Preliminary Drainage Report

The Shire at Old Ranch

PPR2410

February 27, 2024

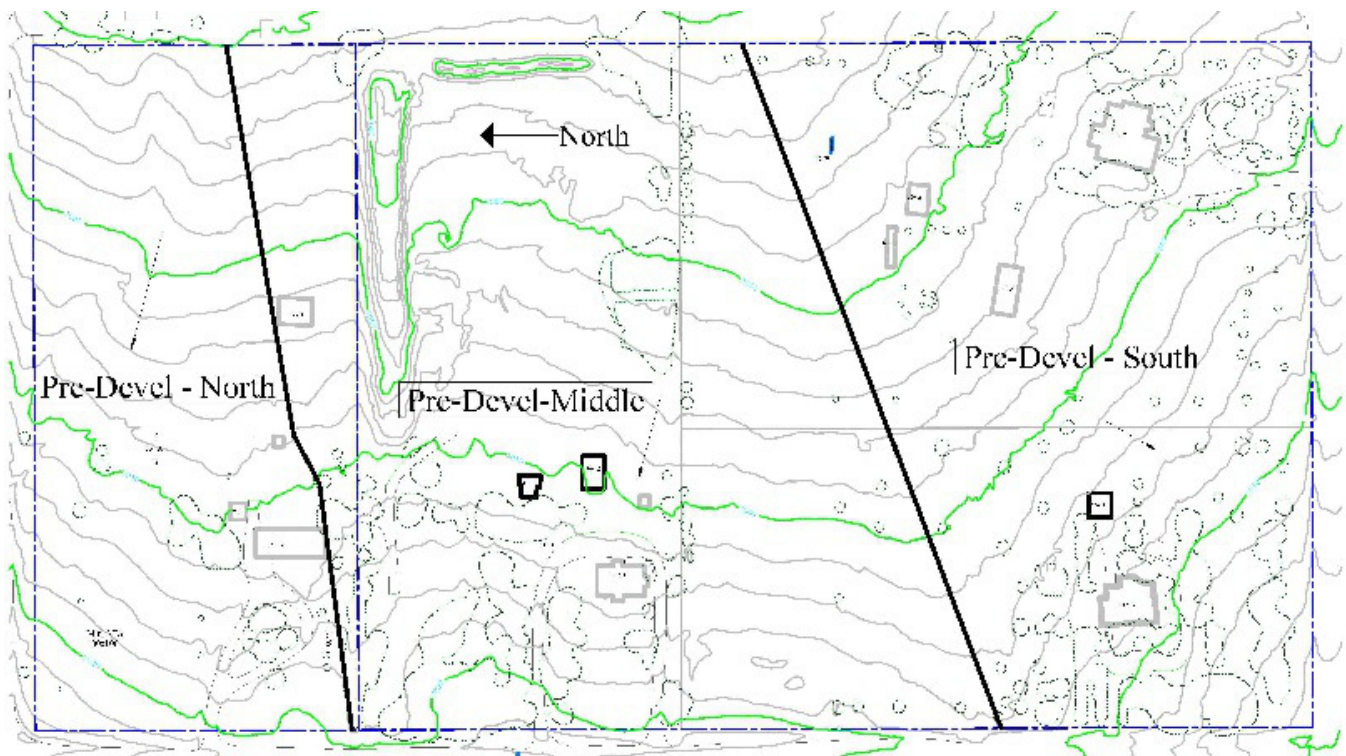
Include project number for reference

Include FIRM grid number

## North SubBasin

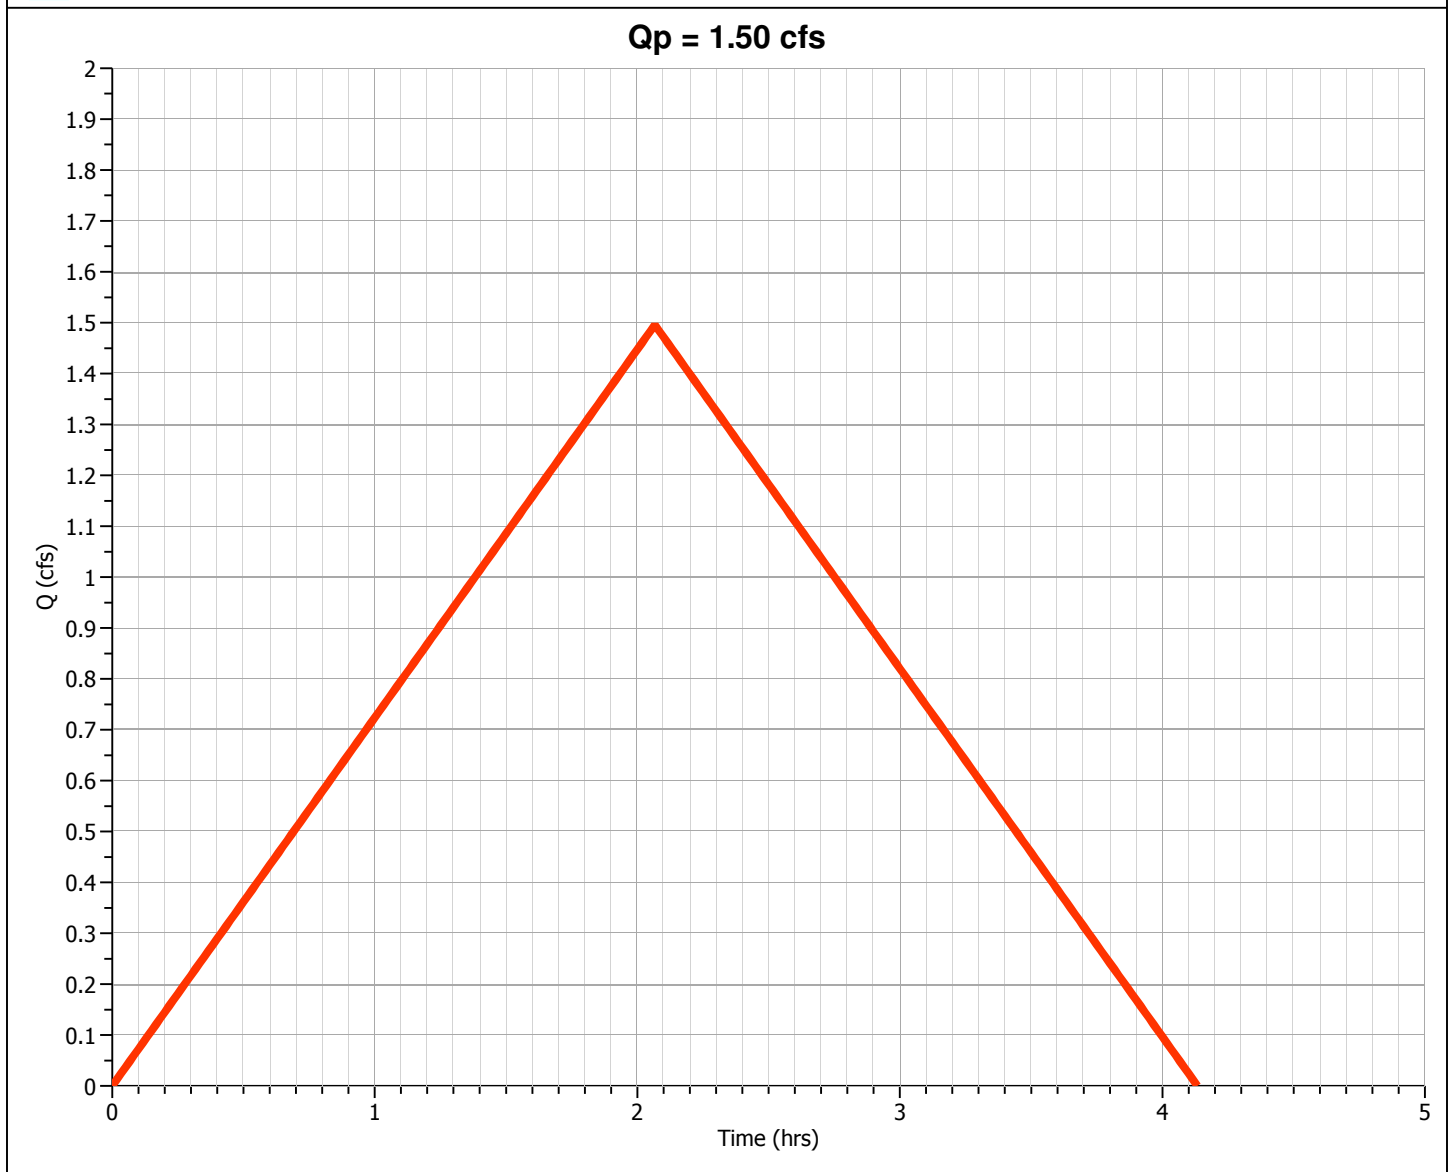
Does not match table, revise (appears to be South basin area)

## South SubBasin

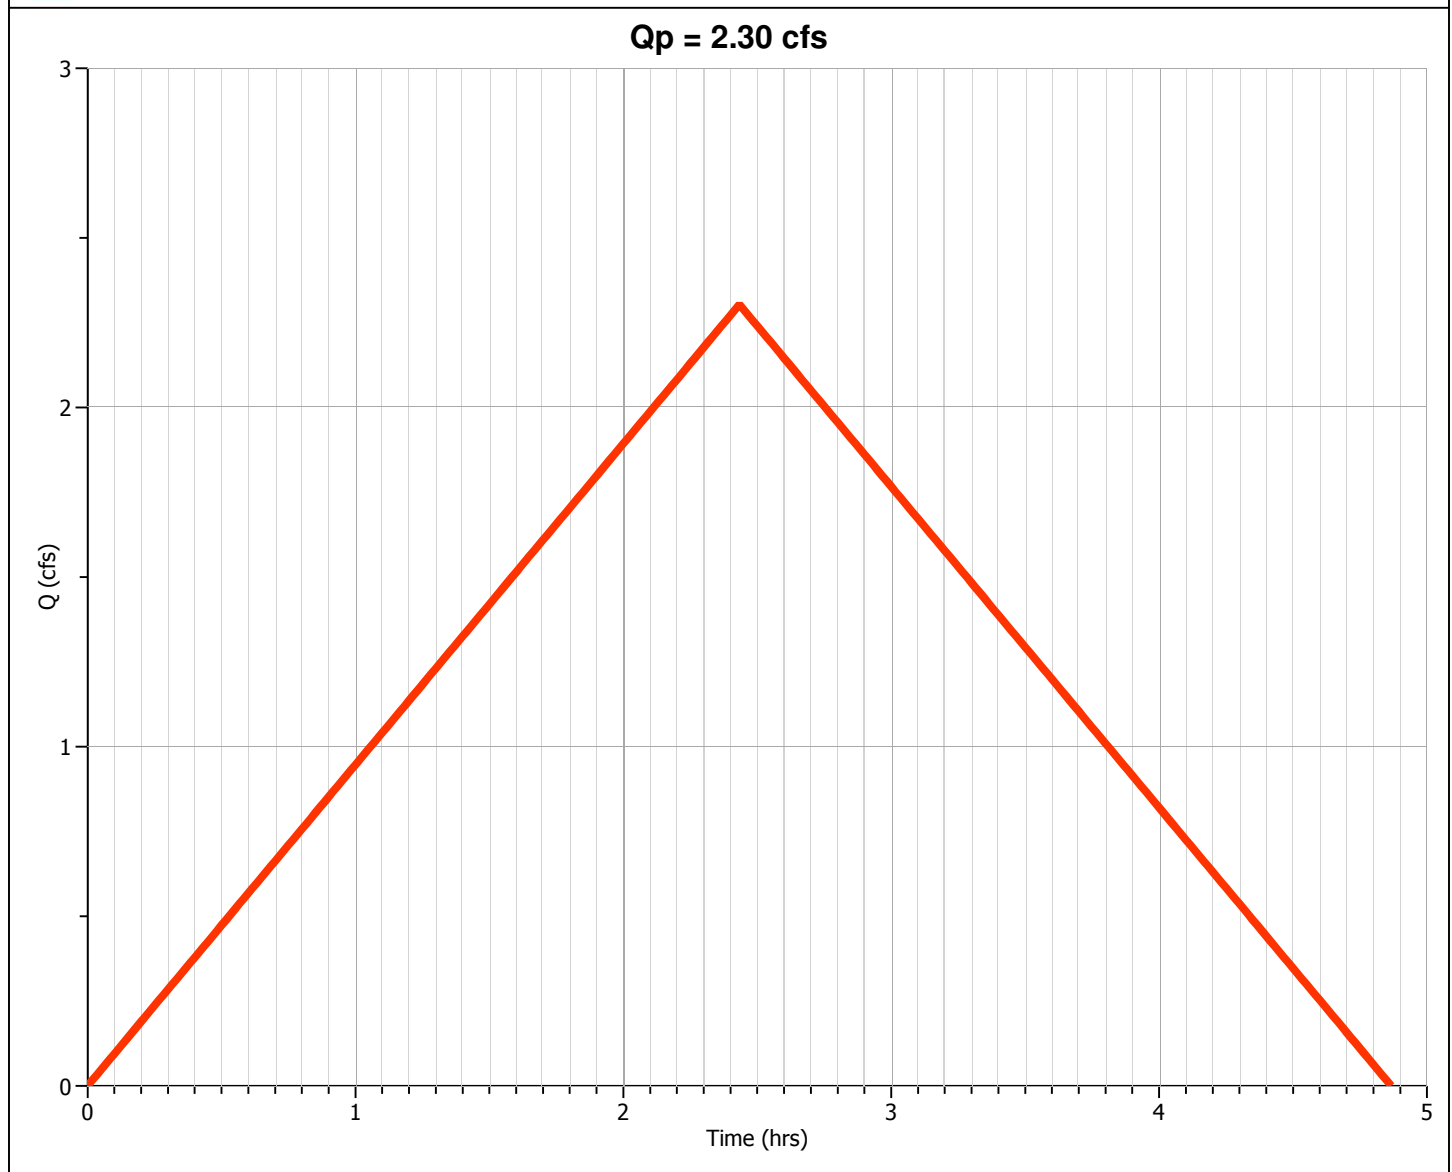
Does not match table, revise (appears to be North basin area)

## North SubBasin

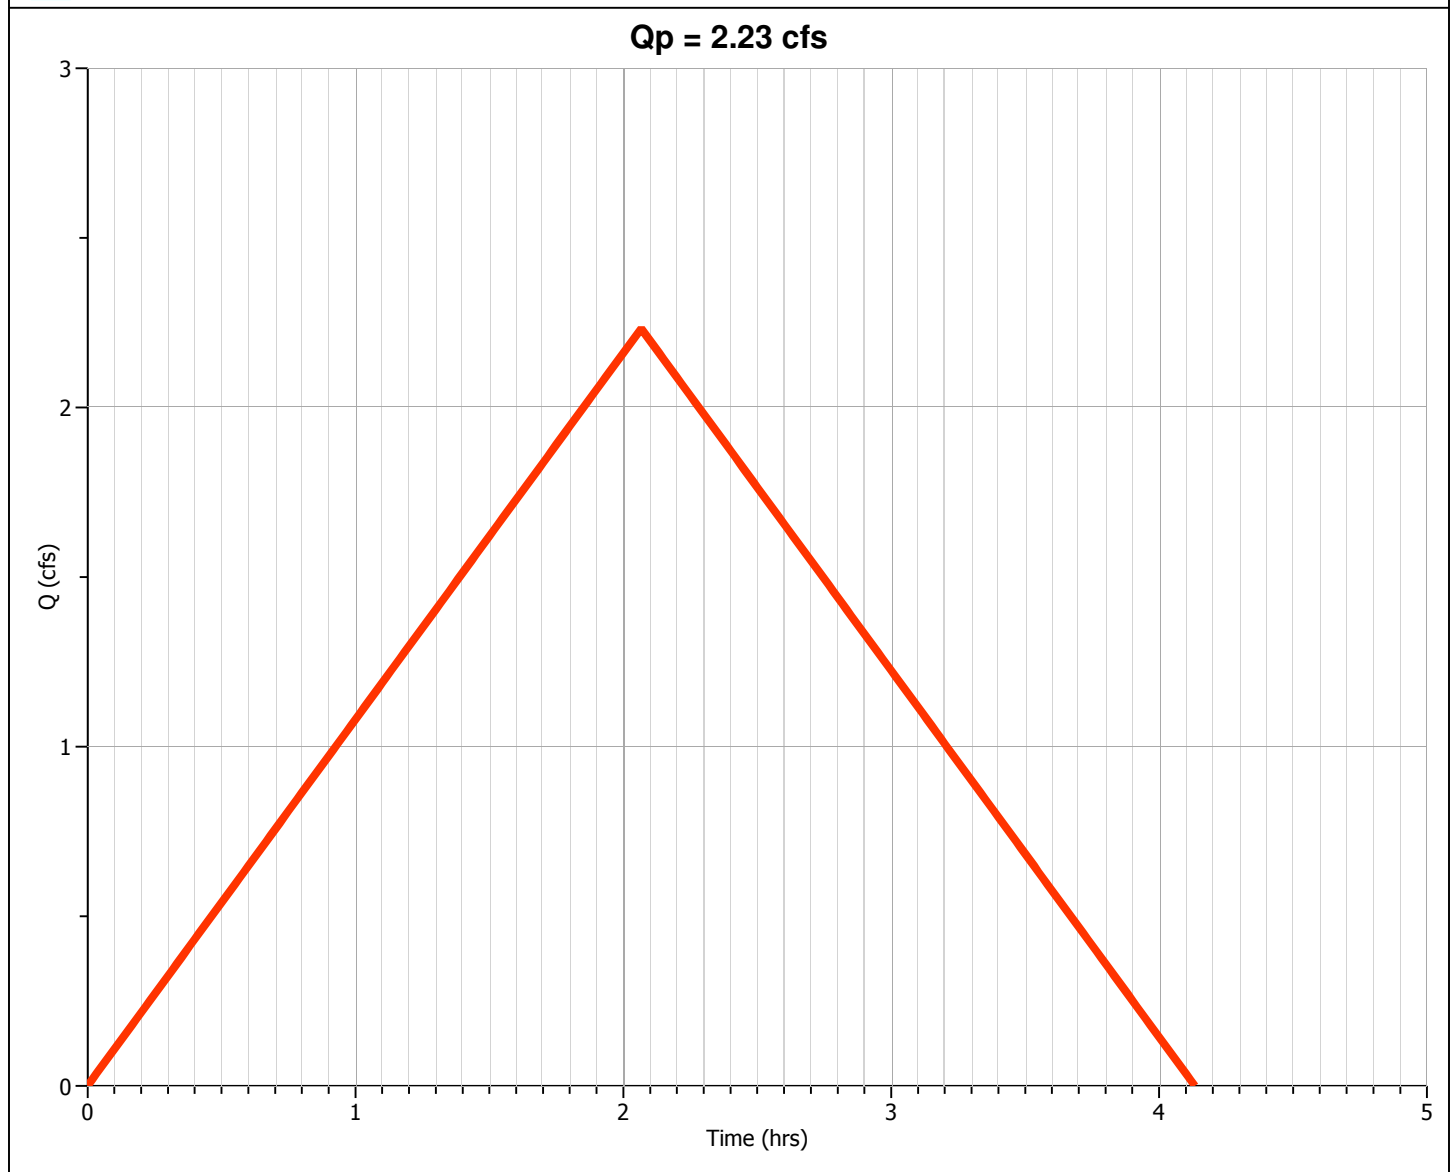
Does not match table,  
revise (appears to be  
South basin area)

## South SubBasin

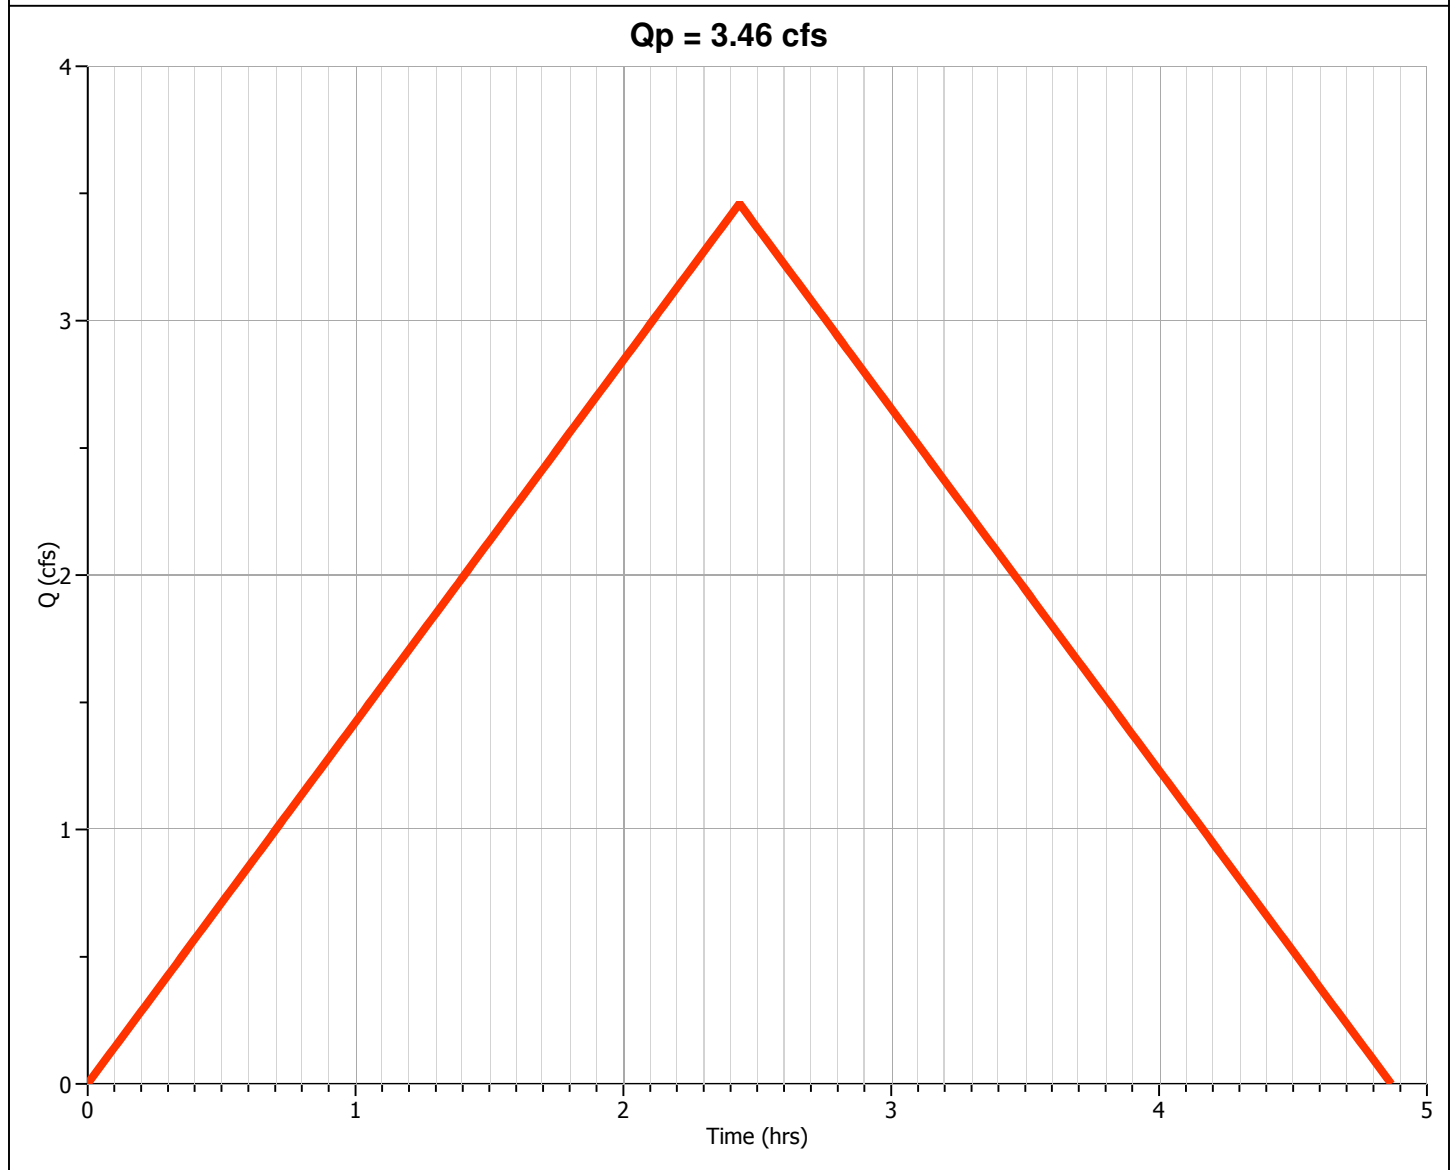
Does not match table, revise (appears to be North basin area)

# Basin 72

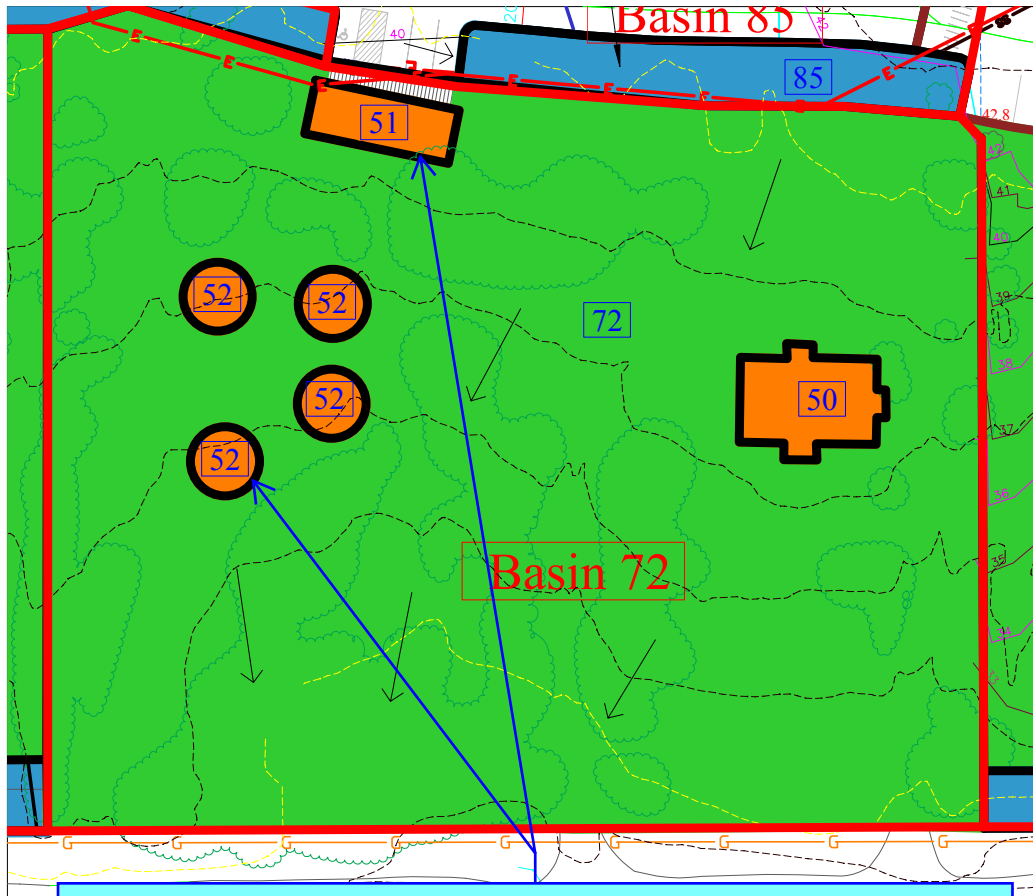
All development within the basin must be treated and increase in flows must be mitigated. Please also account for the proposed path throughout this and other basins. It appears that this flow will flow to the ditch. Provide analysis and indicate whether the ditch is adequate for the increase in flows. Identify where the flows are conveyed to after entering the ditch.

Clarify if any new disturbance/development will occur

# Basin 70

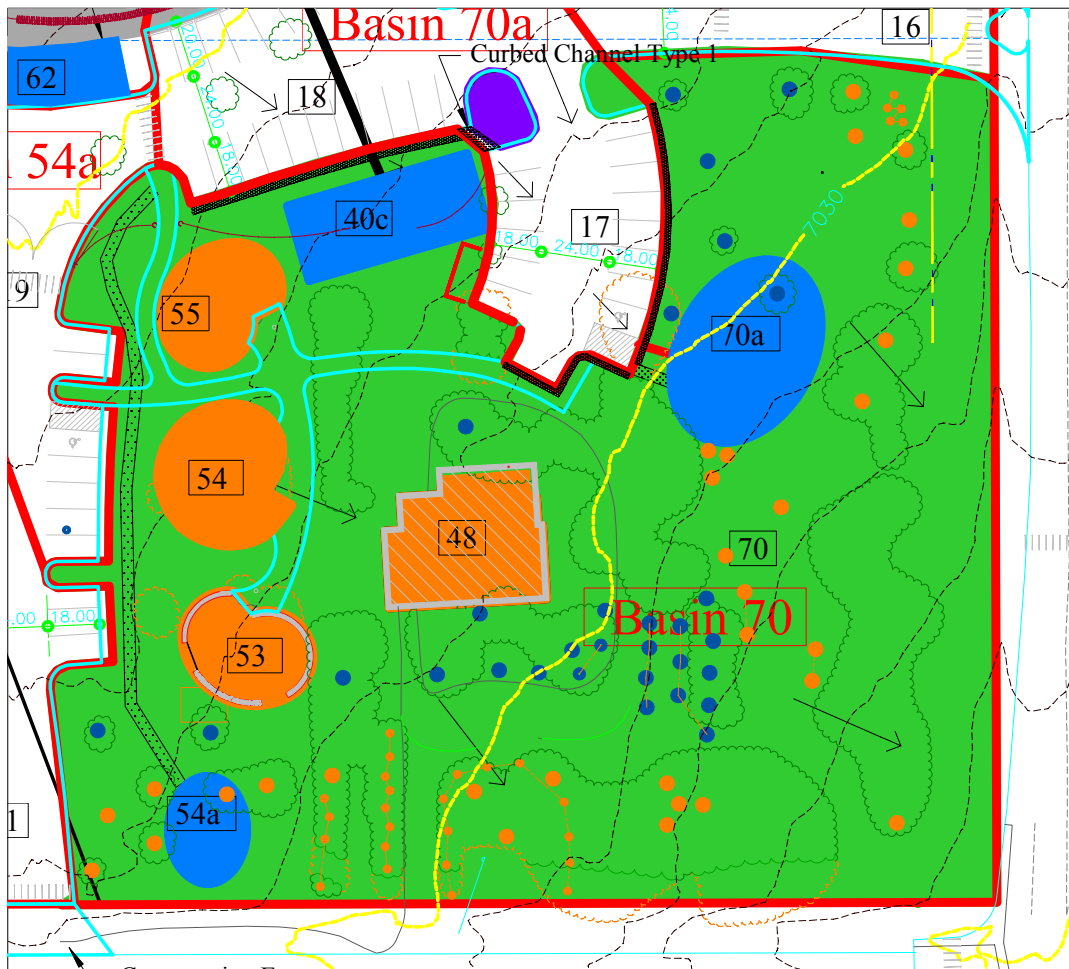
Are the ponds not drainage control? Clearly identify which sections of this basin do not drain to ponds. Clarify if any new disturbance/development will occur

# Basin 92 - Area 16 + 66 + 67 to Free

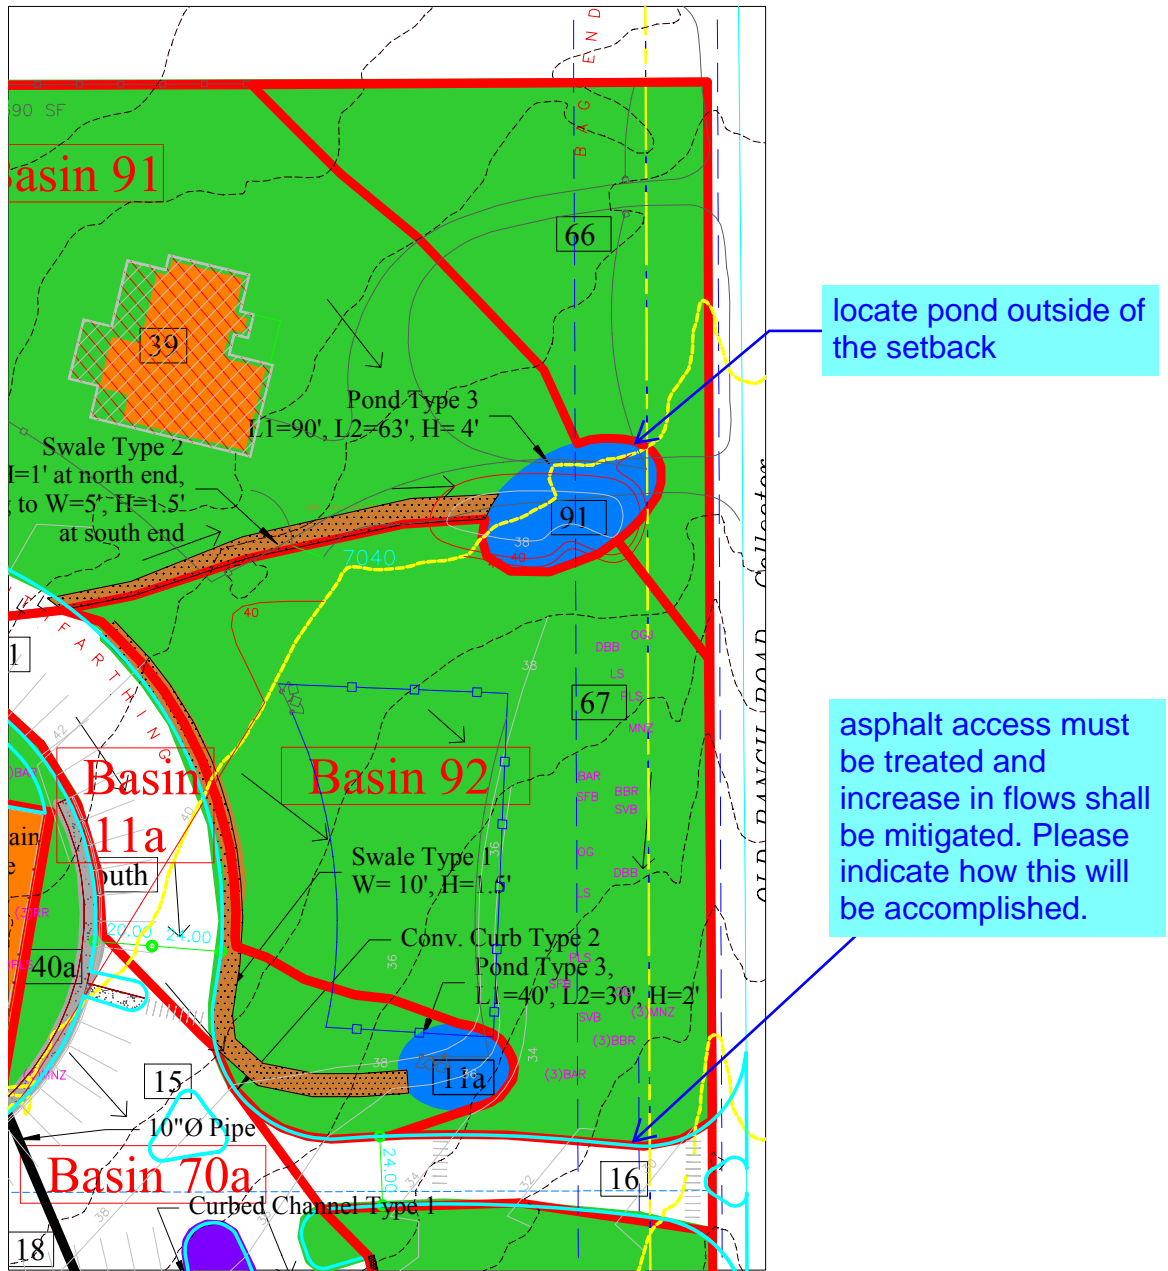
Clarify if any new disturbance/development will occur
